TECHNICAL NOTE

Project Title: Beane Solar Farm

Report Reference: 794-PLN-TRP-JNY11727-04

Beane Solar Farm Technical Note

Title A507 16.5m Articulated Vehicle
Swept Path Analysis

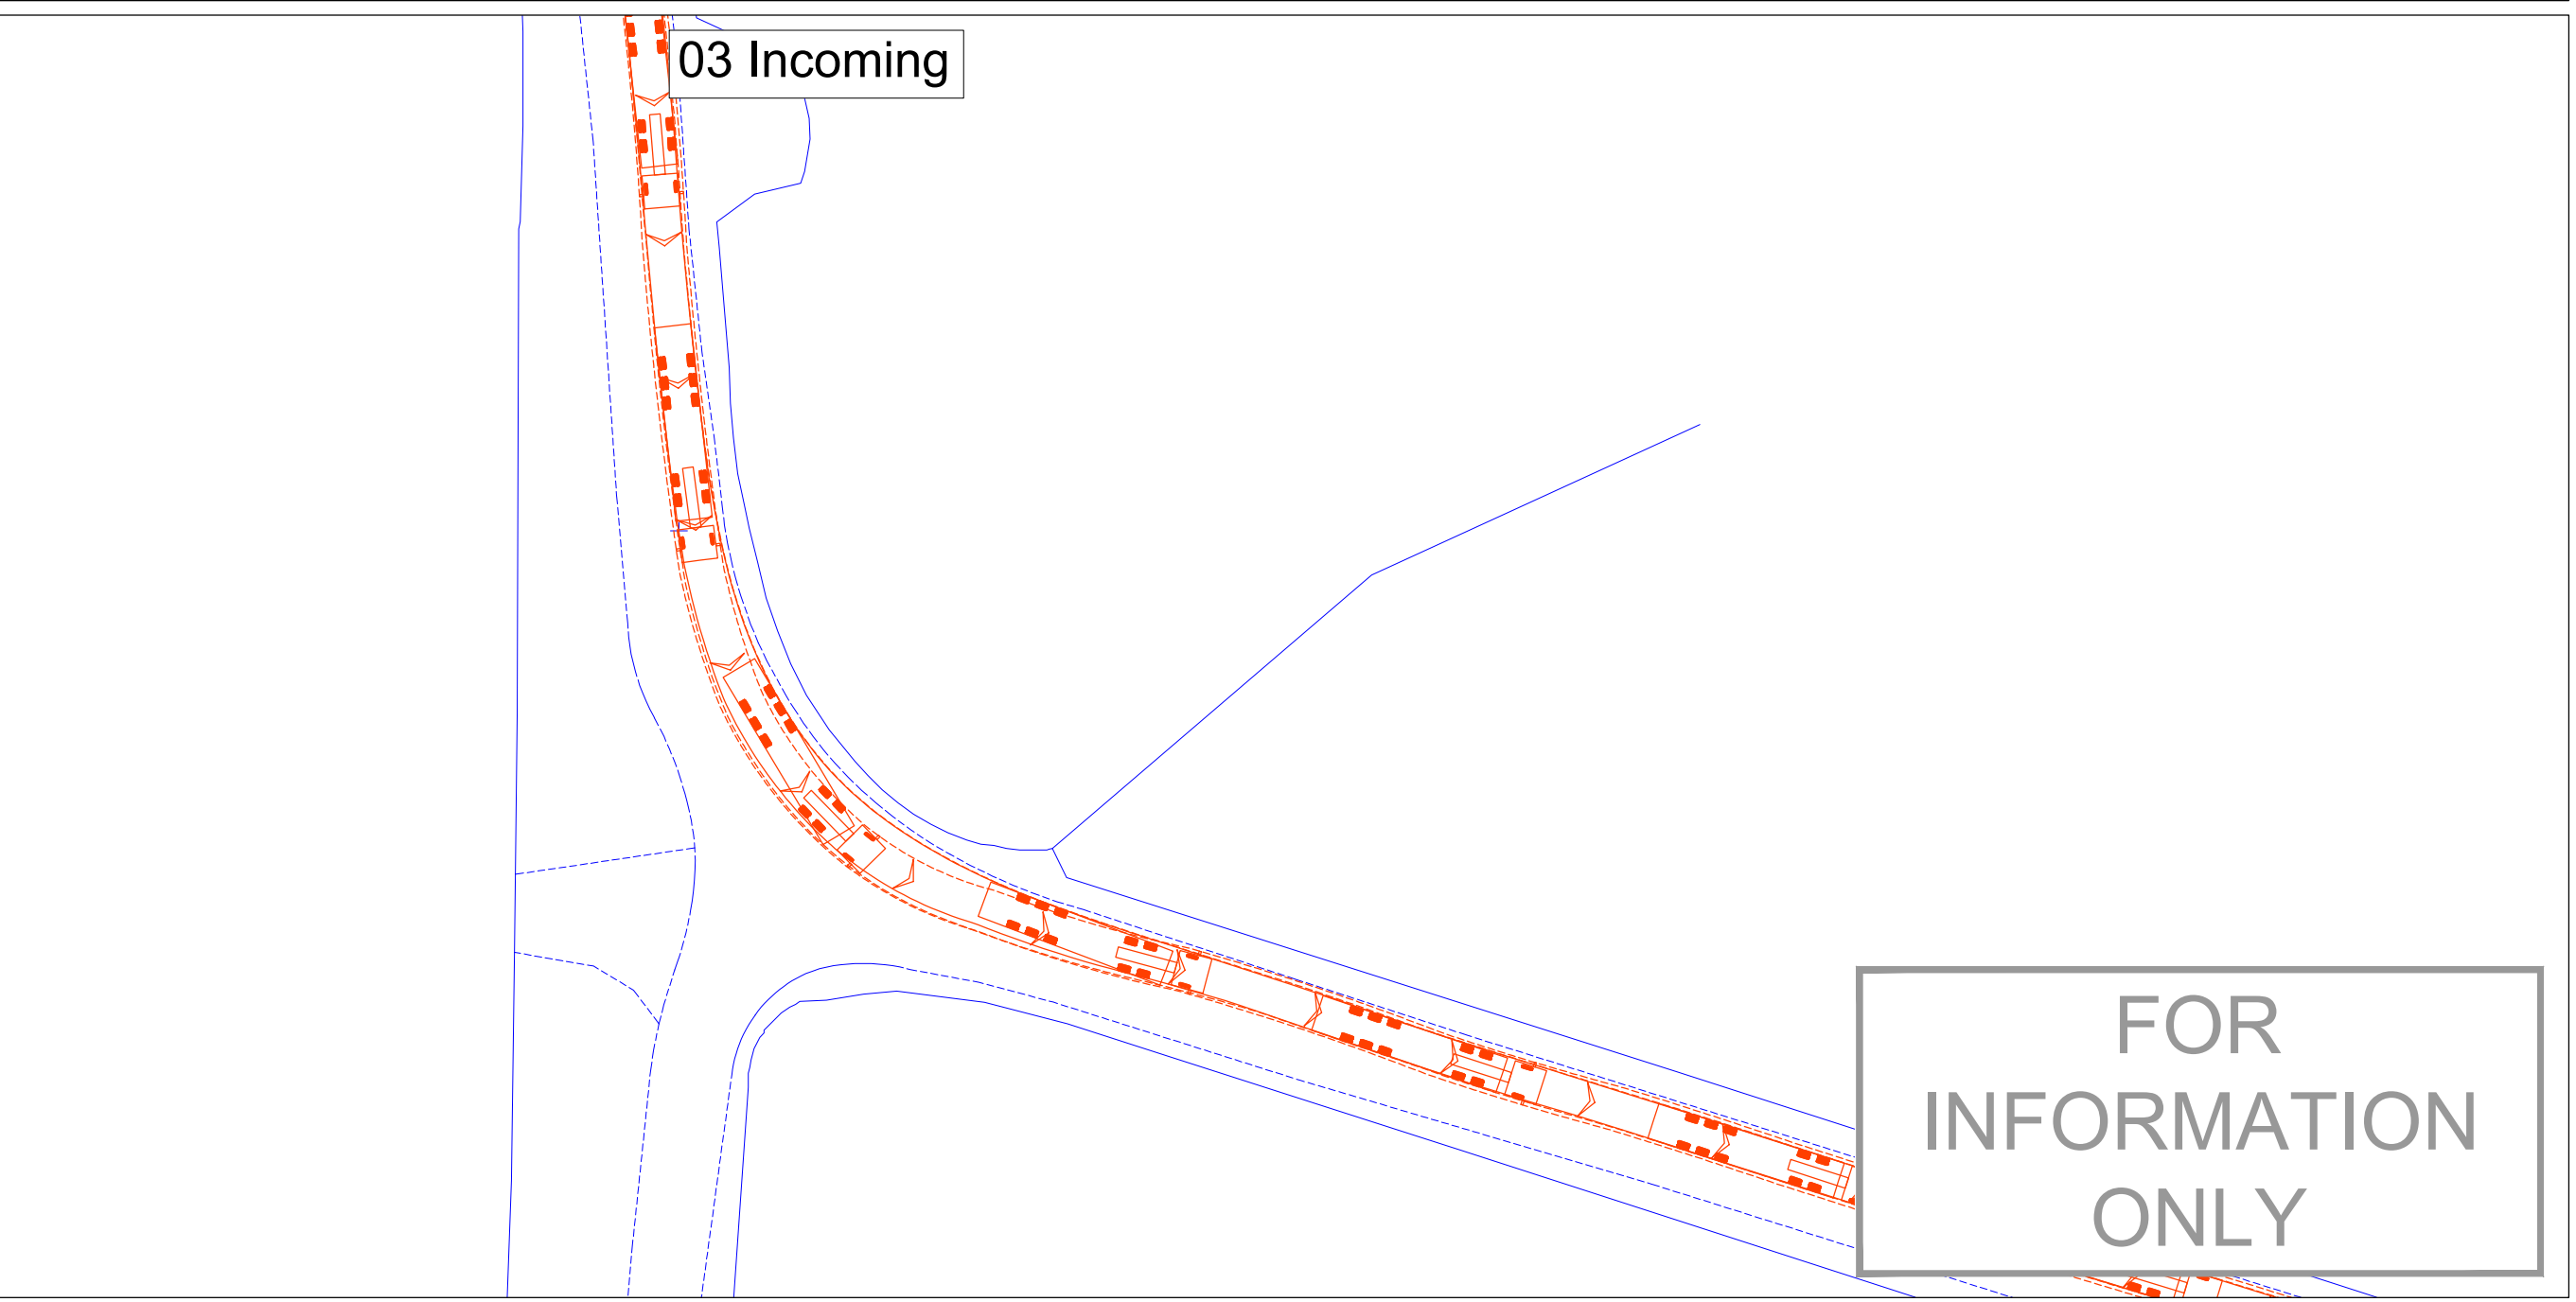
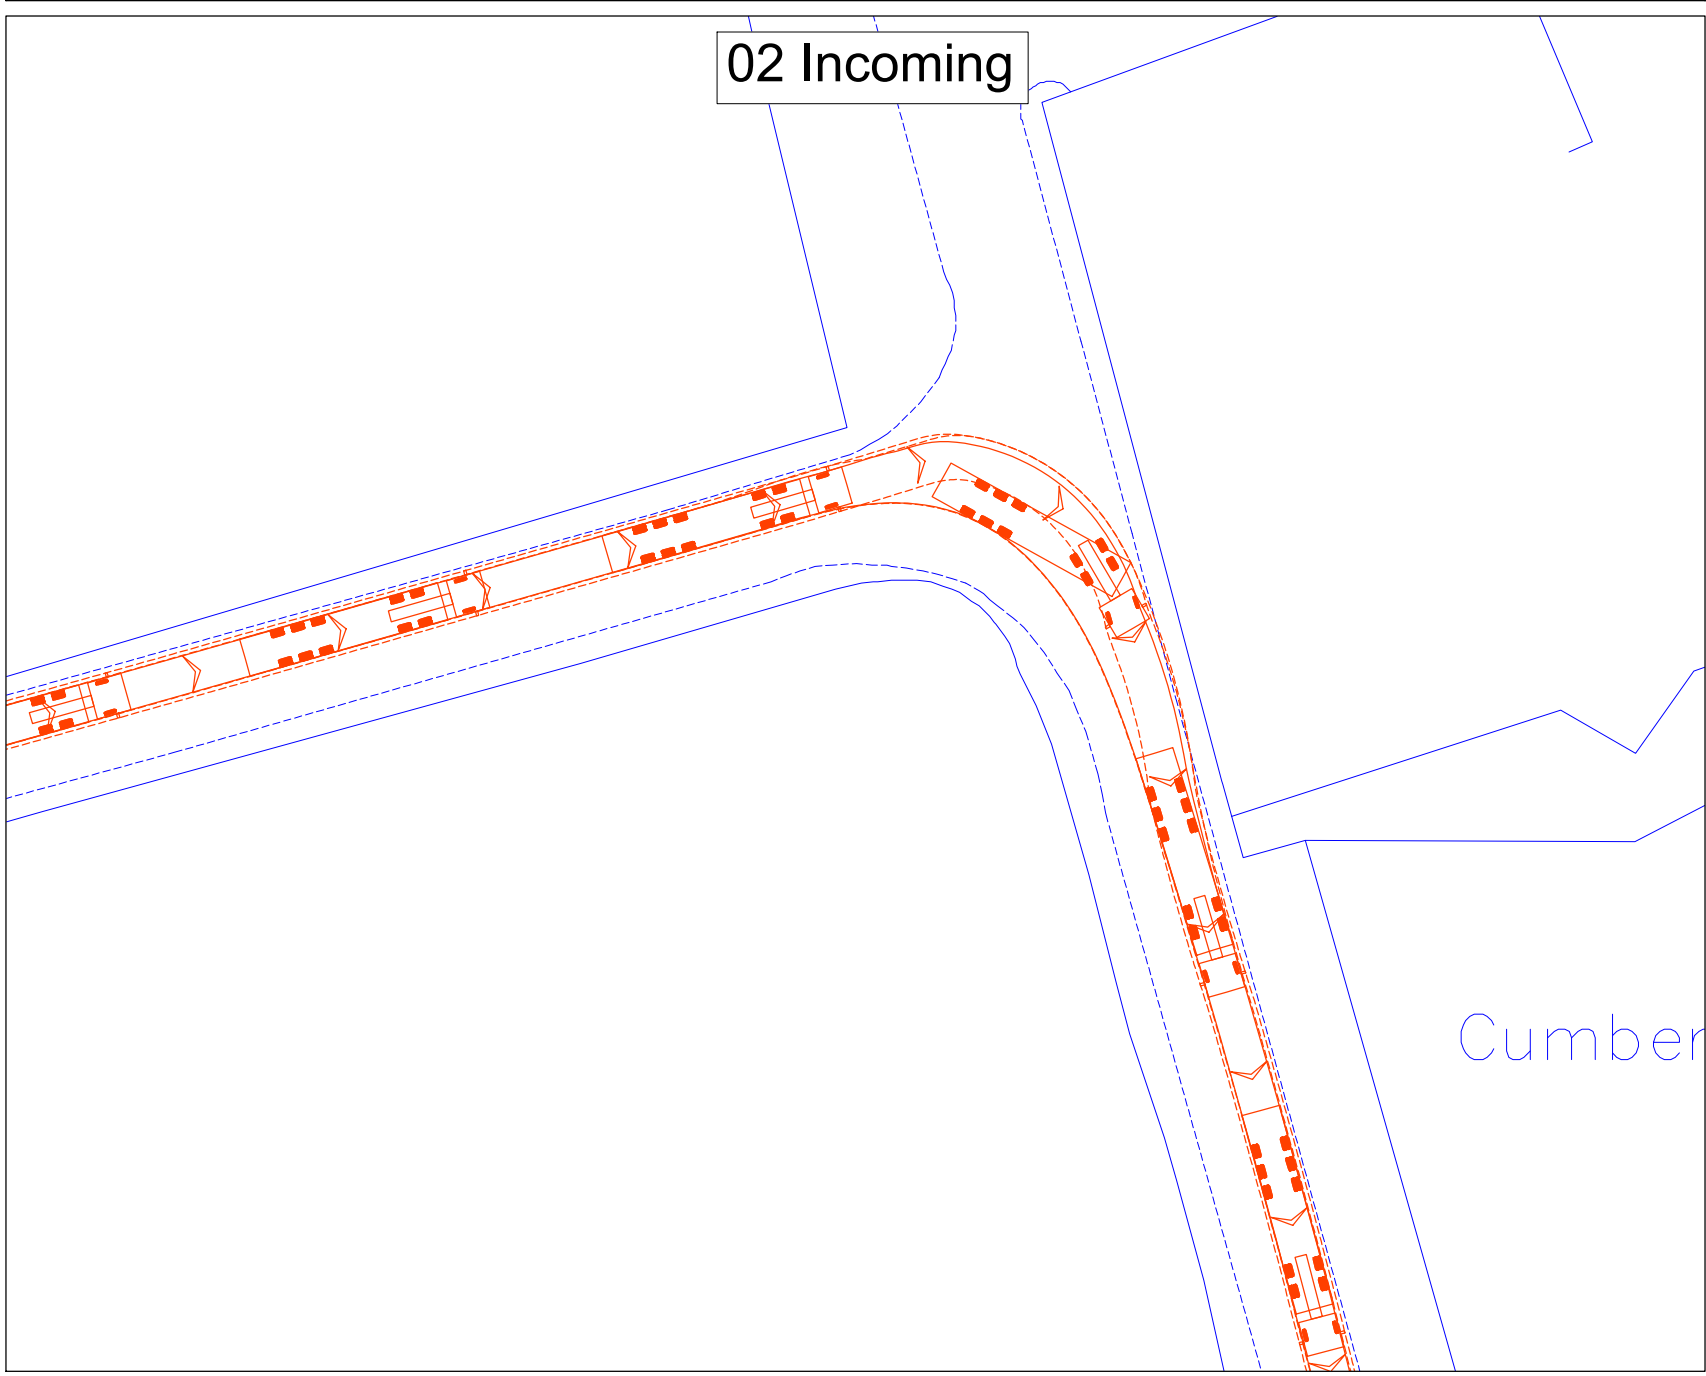
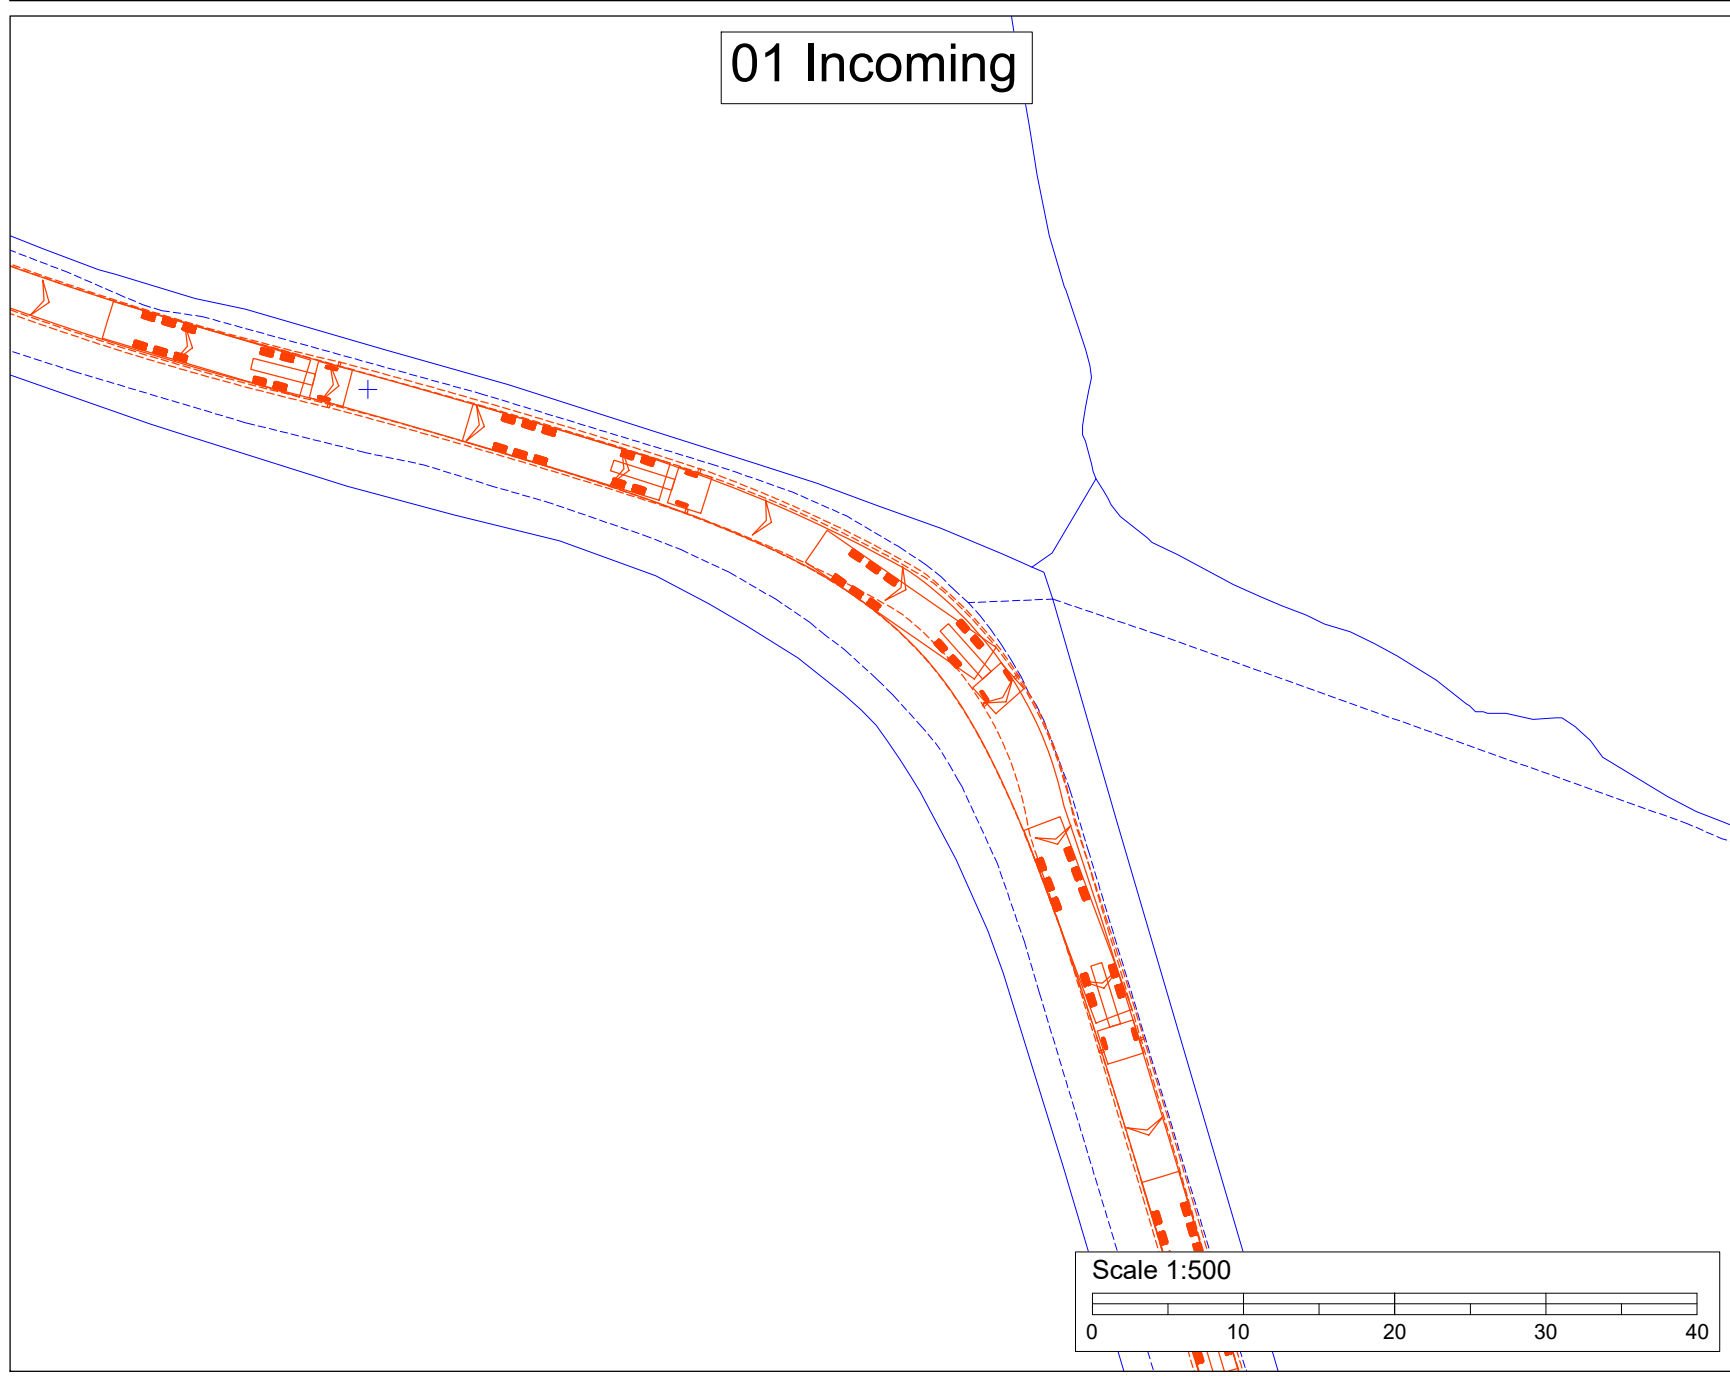
- There is significant concern with construction vehicles exiting the site and driving North West along the A507. Parts of this route is deemed to not be acceptable for large HGV's such as 16.5 metre lorries. Significant concern is Baldock town centre and the Clothall road Junction with the A507 both of these along with this whole route west out of the site will need to be swept pathed."

- 1.29 It should be noted that all construction HGVs arriving and departing to the west will arrive via the A1(M) junction, or the A505 as shown on Figure 6 of the CTMP. On this basis, no construction HGVs will route through Baldock town centre.
- 1.30 A swept path analysis has been undertaken of the A507 to the northwest and southeast of the site, inclusive of the Clothall Road junction, shown at **Appendix 5A-D**, which demonstrates that construction HGVs can travel safely along the proposed access route.
